ATTACHMENT 1

SUPPLEMENTAL REVISIONS TO PROPOSED TECHNICAL SPECIFICATION CHANGE

Pages 6.1-1, 6.1-6, 6.4-5, and Figure 6.1-2 were previously submitted on November 2, 1984 (S.N. 577). The attached pages supercede the corresponding pages in that submittal. Page 6.4-2 is also attached for the first time.

DISCUSSION OF PROPOSED SUPPLEMENTAL TECHNICAL SPECIFICATION CHANGES

SURRY POWER STATION ORGANIZATION CHART

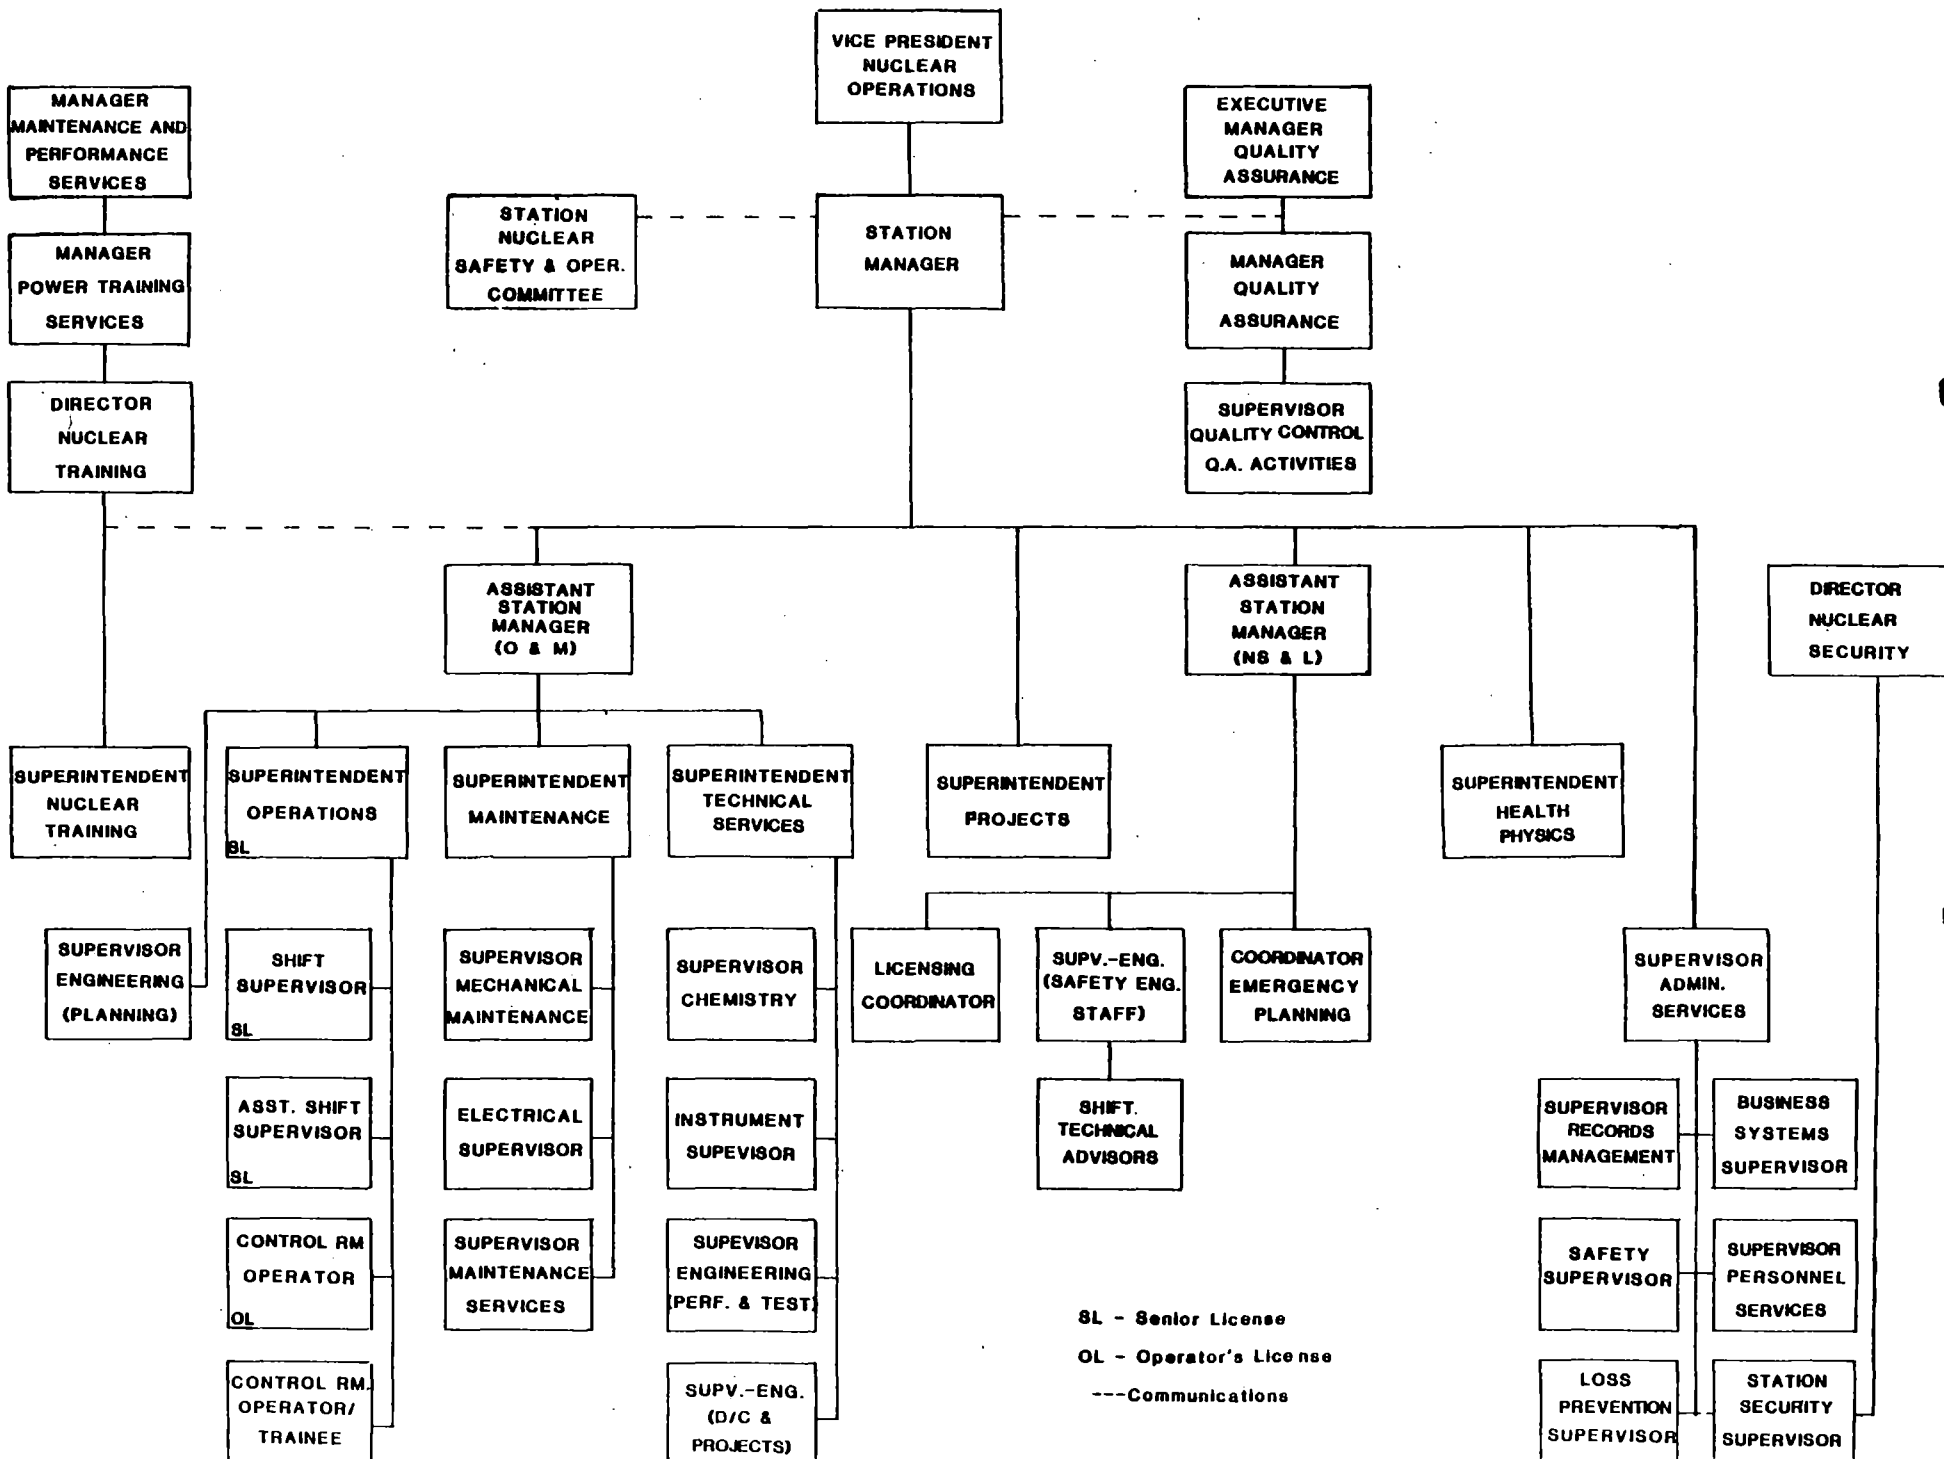
The proposed Technical Specification change reflects the most recent reorganization within the Nuclear Operations Department, and supplements the previously proposed reorganization changes which were submitted to the NRC on November 2, 1984 (SN:577). The specifics of this change request deal with the addition of the position of Superintendent-Health Physics. All previous Technical Specification references to the Supervisor-Health Physics have been changed to the Superintendent-Health Physics. This title change is commensurate with the responsibilities associated with the Health Physics organization at Surry.

The Superintendent-Health Physics directs the activity of the Health Physics Group at the station, ensuring that all data are correctly interpreted and acted on as necessary. He is directly responsible to the Station Manager and coordinates his efforts with the Superintendent-Operations, the Superintendent-Maintenance, and the Superintendent-Technical Services.
